APPLICATION FOR PERMIT TO DRILL		5. MINERAL LEASE NO: ML-21329	6. SURFACE: State
1A. TYPE OF WORK: DRILL <input checked="" type="checkbox"/> REENTER <input type="checkbox"/> DEEPEN <input type="checkbox"/>		7. IF INDIAN, ALLOTTEE OR TRIBE NAME:

2. NAME OF OPERATOR: KERR MCGEE OIL & GAS ONSHORE L.P.		9. WELL NAME and NUMBER: NBU 1021-28B	
3. ADDRESS OF OPERATOR: 1368 S 1200 E CITY VERNAL STATE UT ZIP 84078		PHONE NUMBER: (435) 781-7024	10. FIELD AND POOL, OR WILDCAT: NATURAL BUTTES

**NBU 1021-28B
NW/NE SEC. 28, T10S, R21E
Uintah County, UT
ML-21329**

APPROXIMATE TOTAL 8" PIPELINE DISTANCE = 12,100' +/-

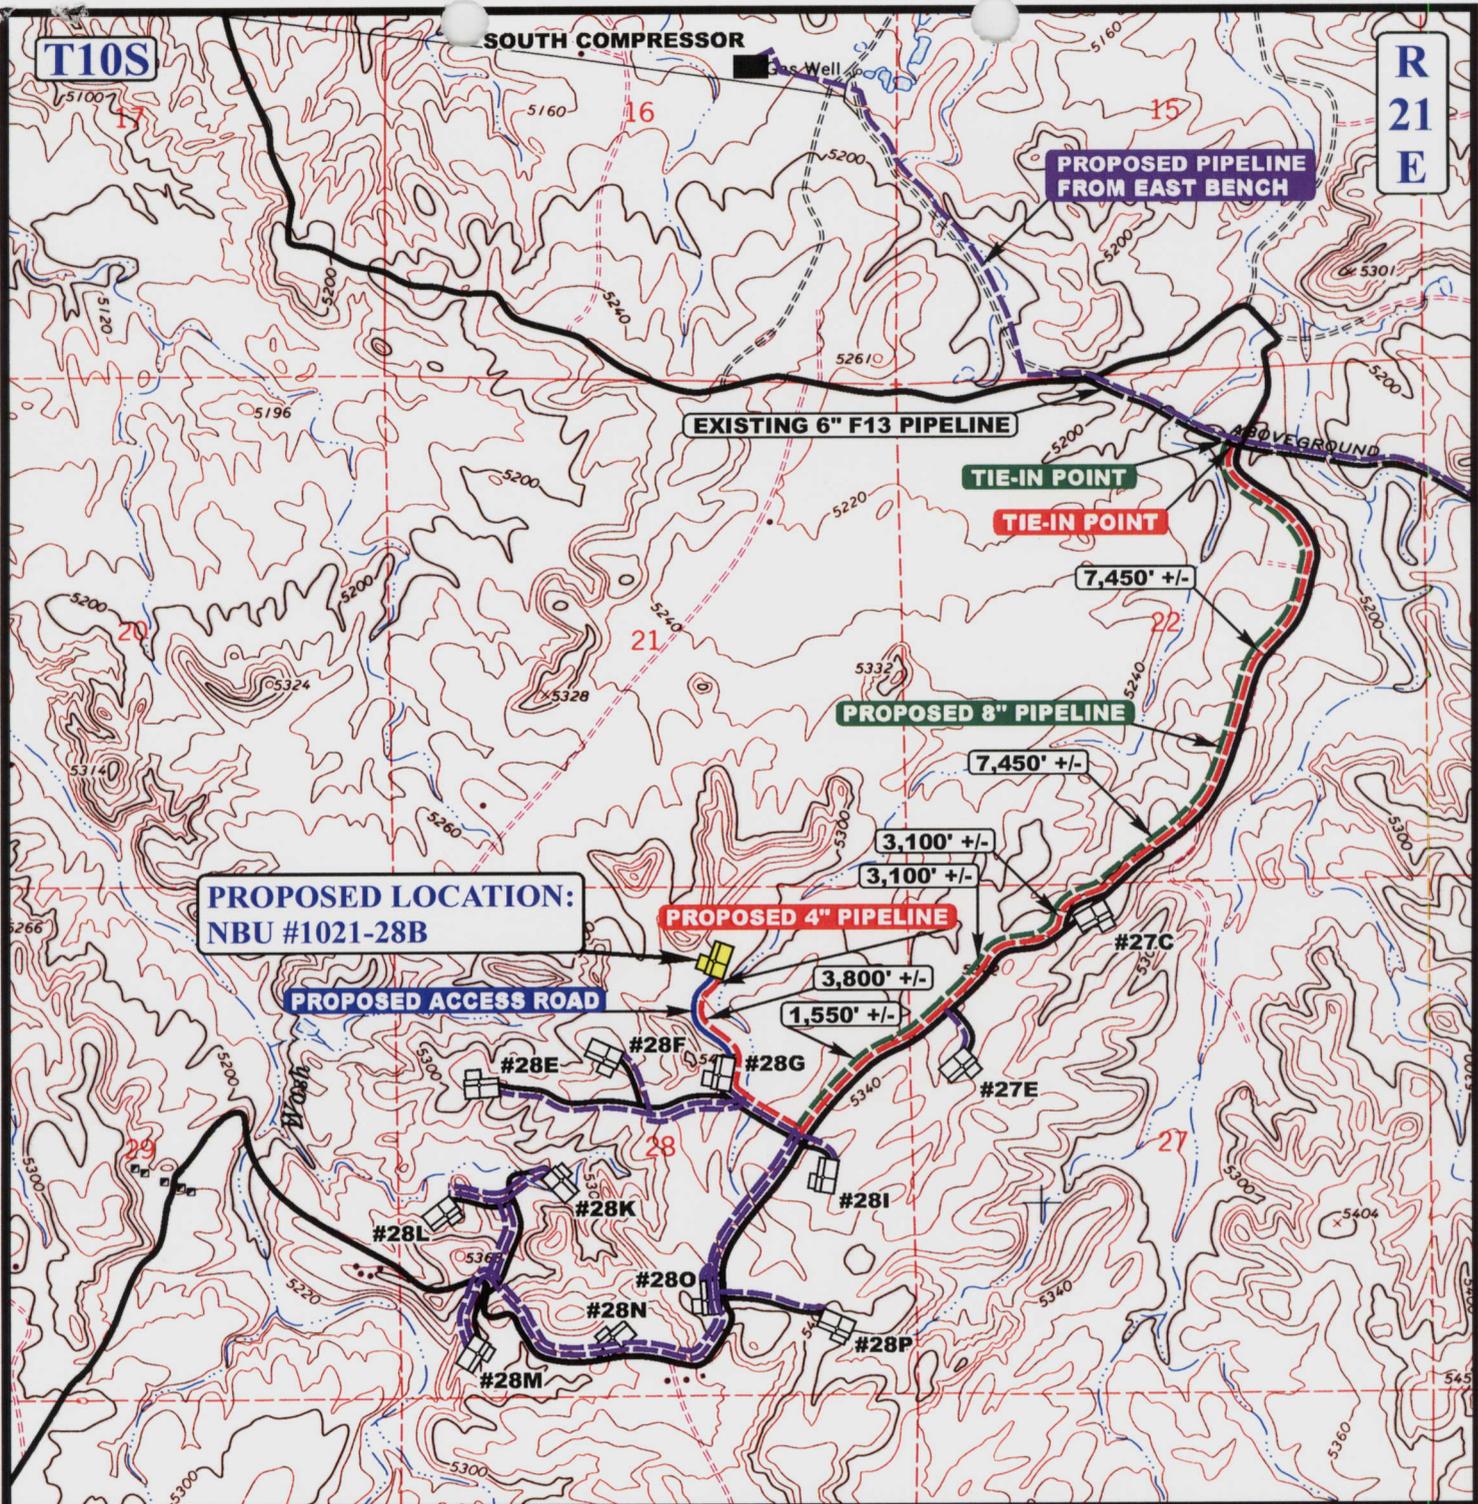
An onsite was conducted on 4/5/07 with the Division of Oil, Gas and Mining Representative and SITLA Representative. It was decided to change the proposed pipeline from a 4" pipeline that was approximately 1,095' +/- to a 4" pipeline approximately 14,350' +/- and an 8" pipeline approximately 12,100' +/- . These pipelines also cross onto Federal lands in Sec 27 and tie into a point in Sec 22 of T10S-R21E.

APPROXIMATE TOTAL 8" PIPELINE DISTANCE = 8,750' +/-

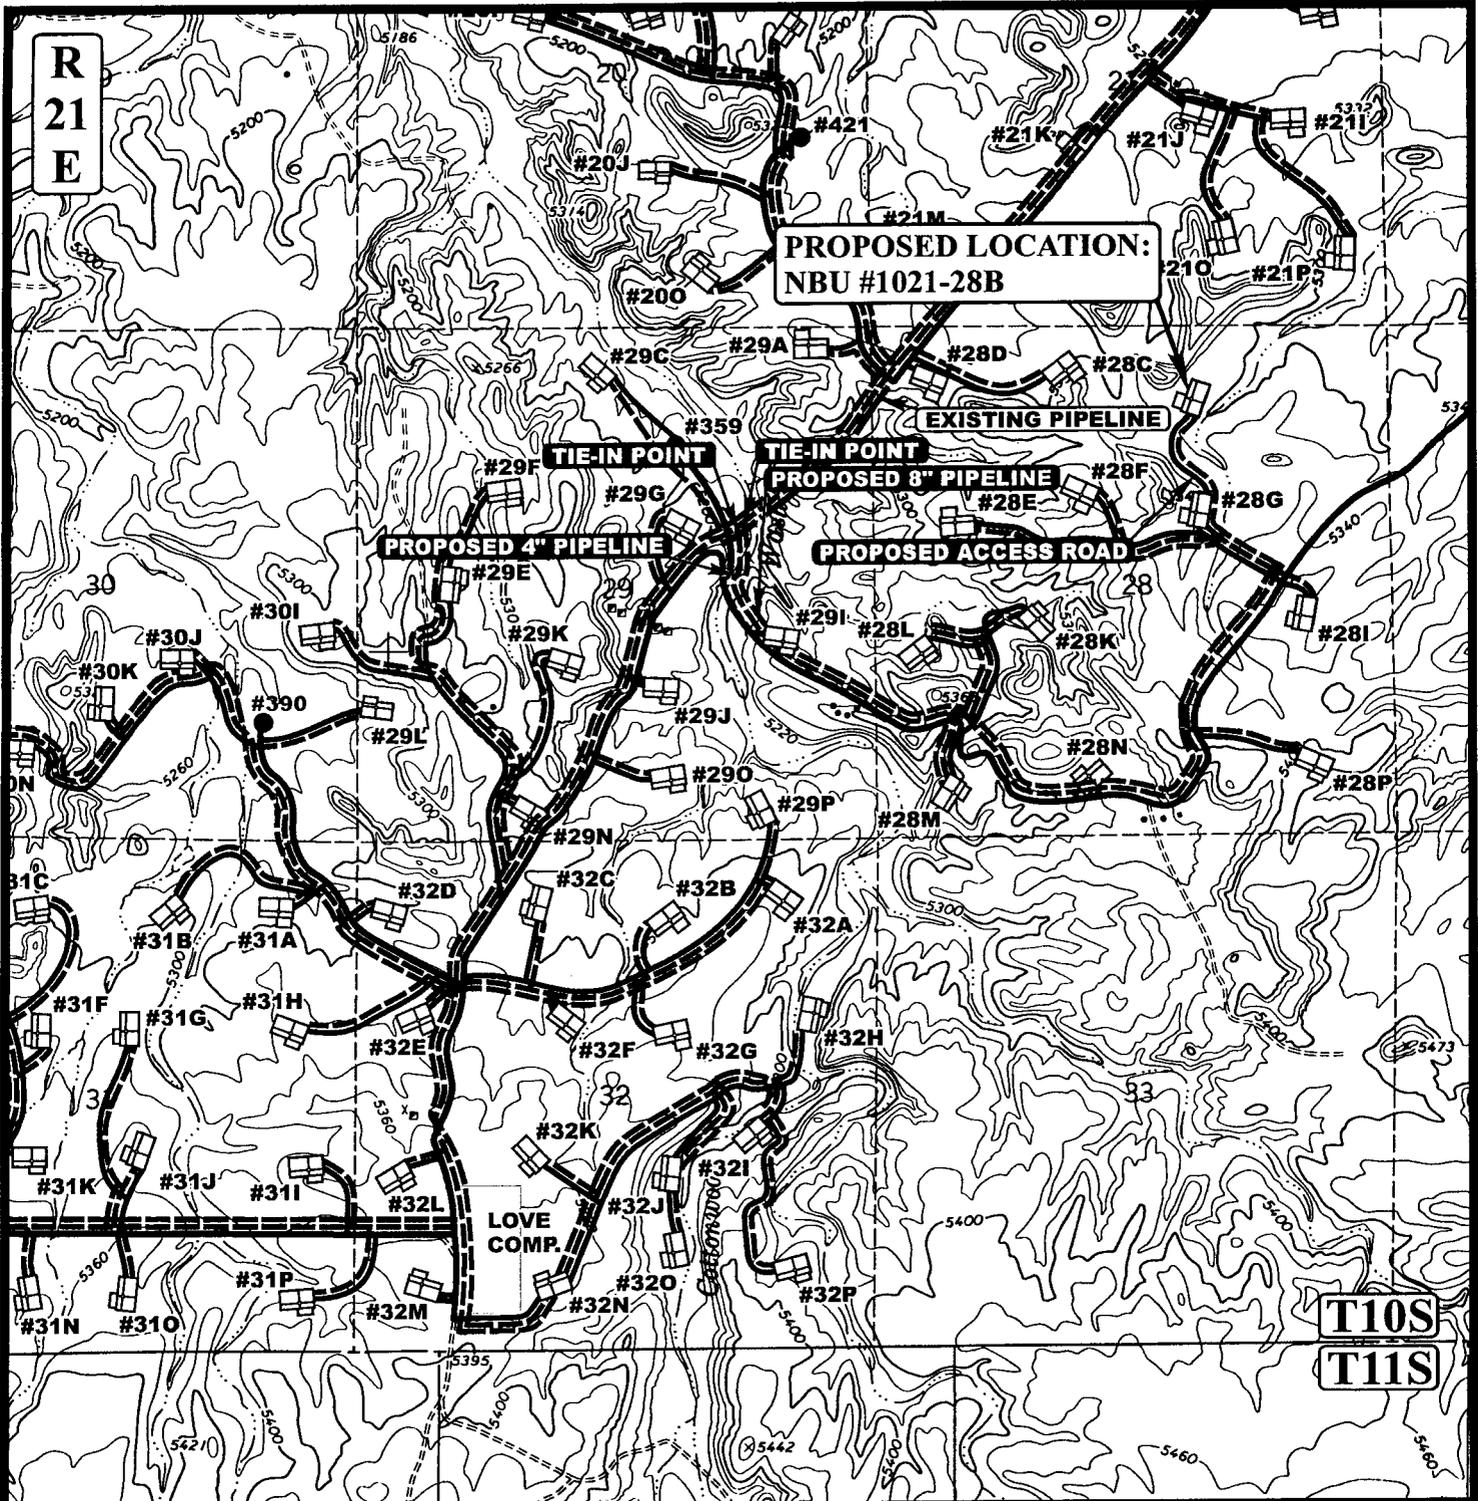
An onsite was conducted on 4/5/07 with the Division of Oil, Gas and Mining Representative and SITLA Representative. It was decided to change the proposed pipeline from a 4" pipeline approximately 14,350' +/- and an 8" pipeline approximately 12,100' +/- to a 4" pipeline approximately 11,150' +/- and an 8" pipeline approximately 8,750' +/-.

Please replace the sundry dated 4/18/07 with this sundry dated 5/8/07.
